V1: 12AX7 V2: 12AT7 V3: 12AX7 V4: 12AX7 V5: 6V6GT V6: 5Y3
Vibro Champ Reverb Preamp, power amp, reverb

Vibro Champ Reverb
Tremolo and power suppy

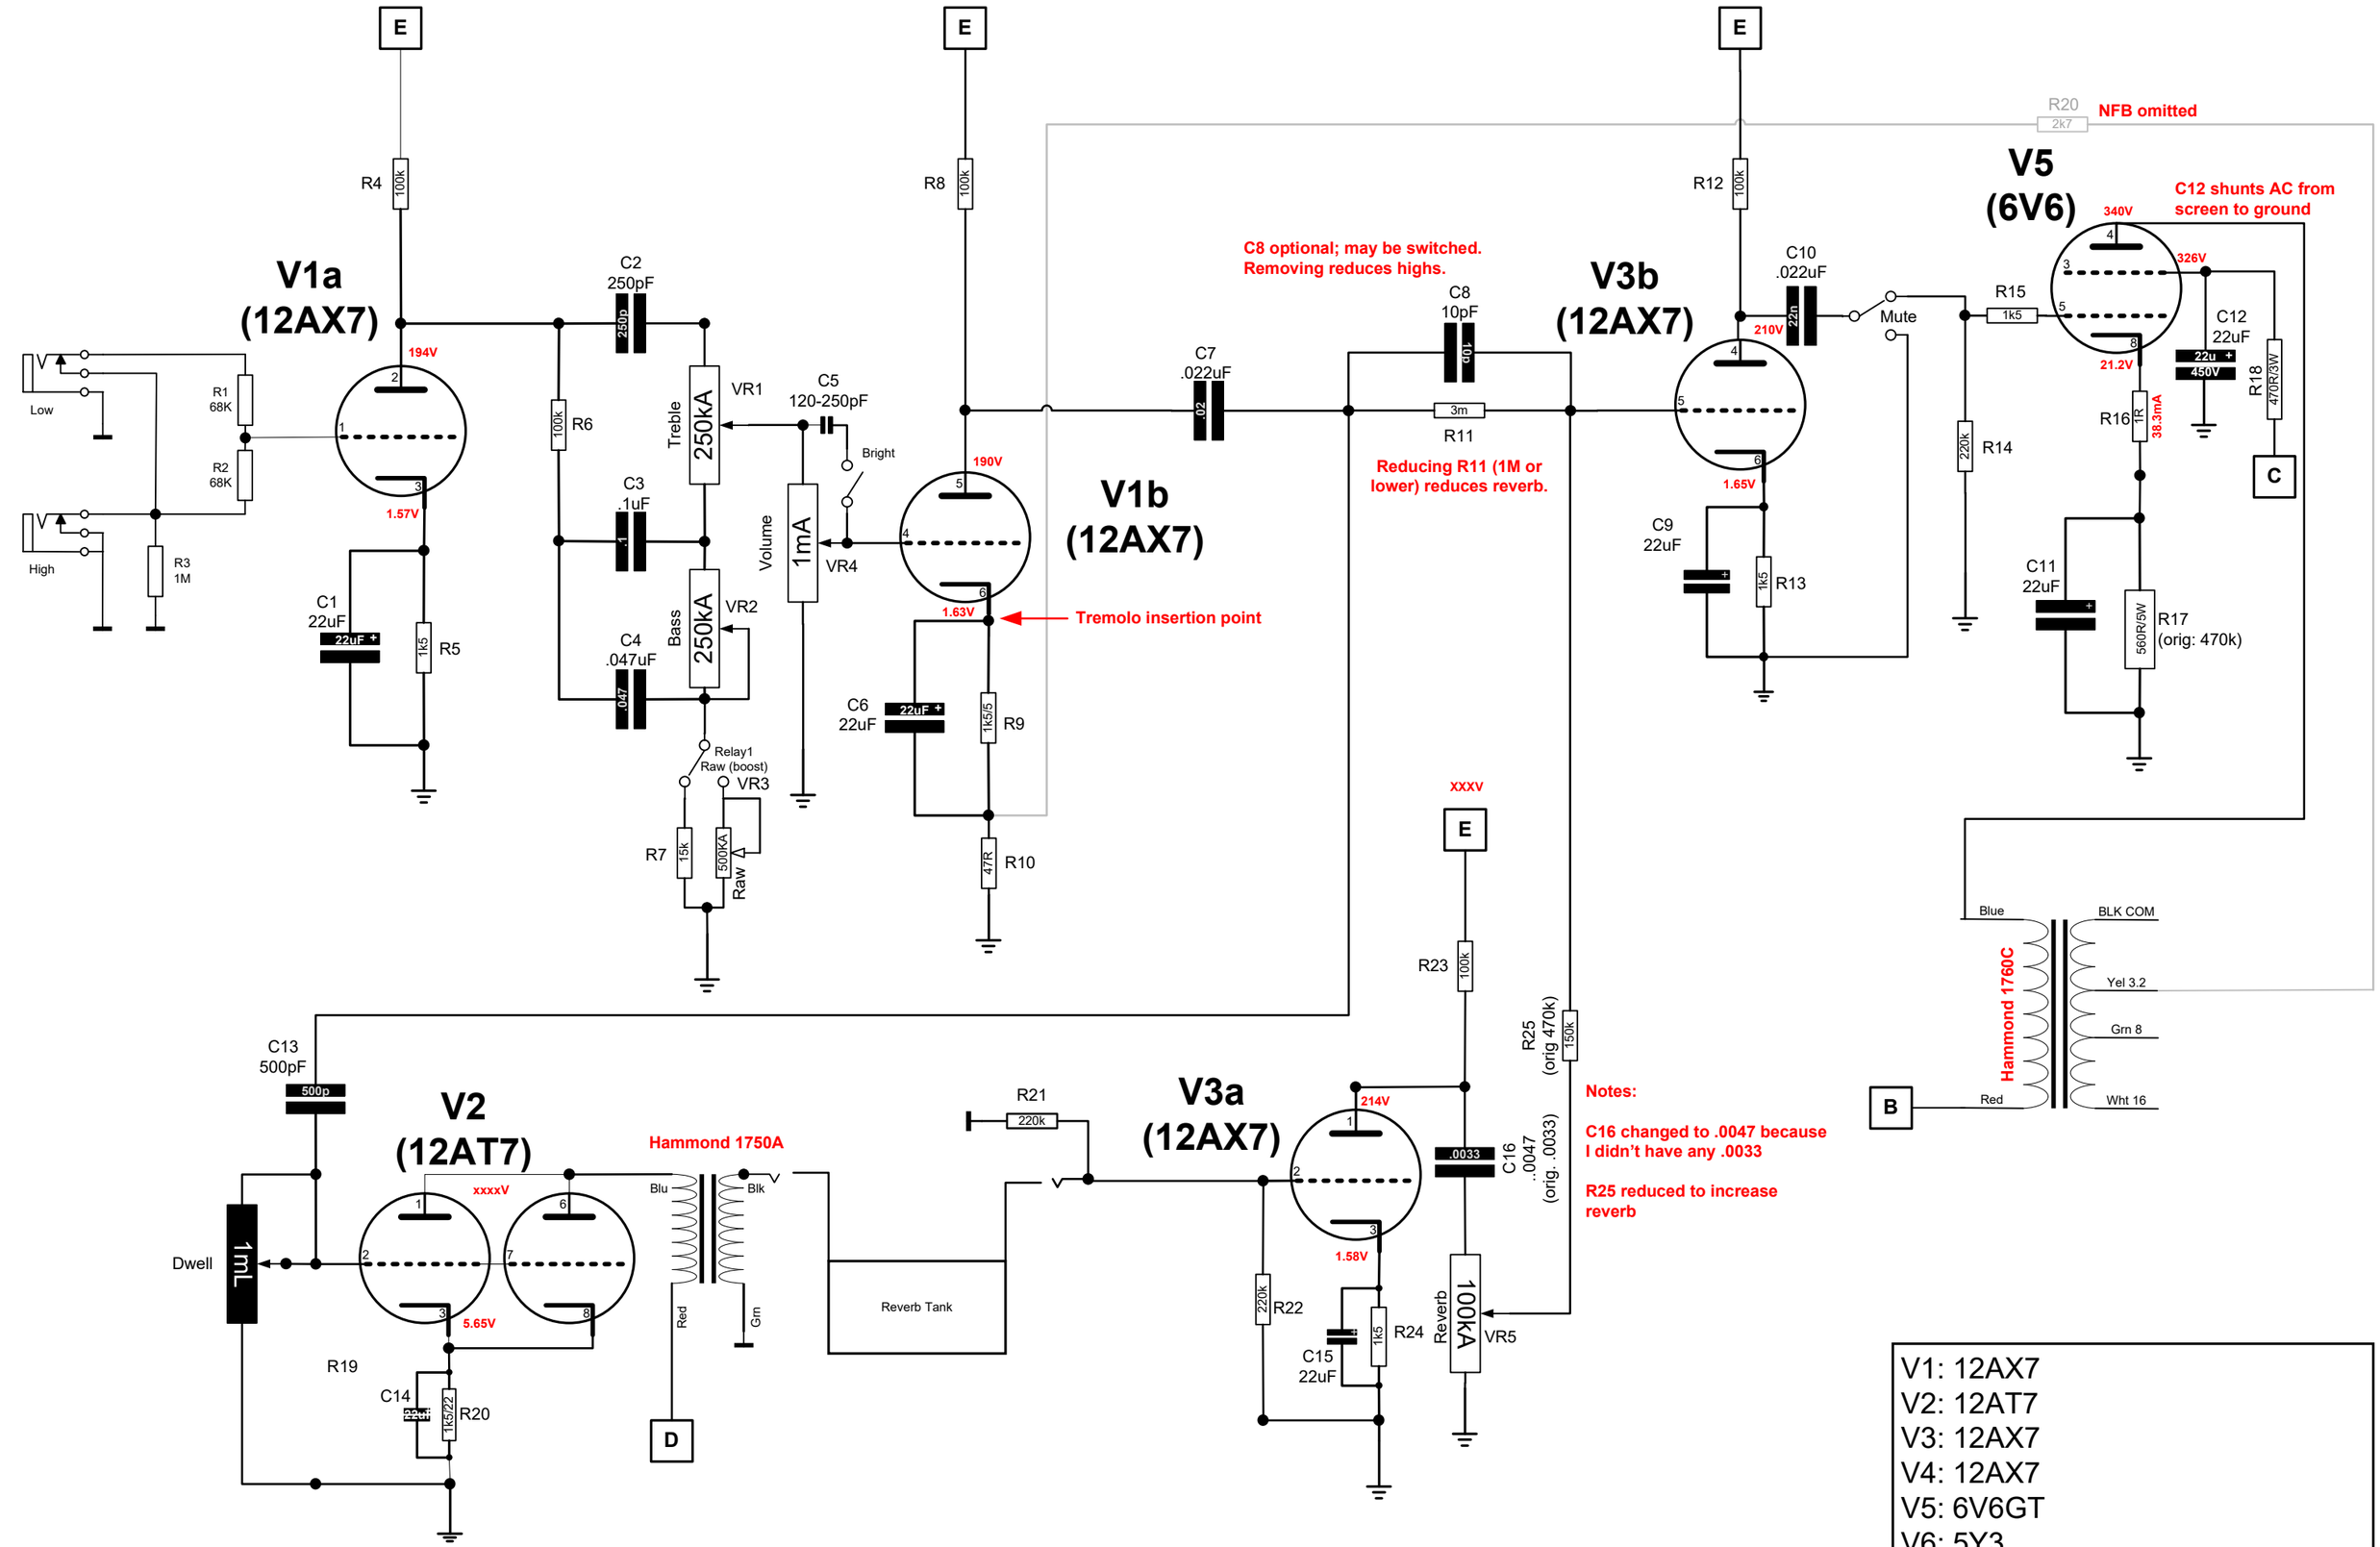
C16 changed to .0047 because I didn't have any .0033

R25 reduced to increase reverb
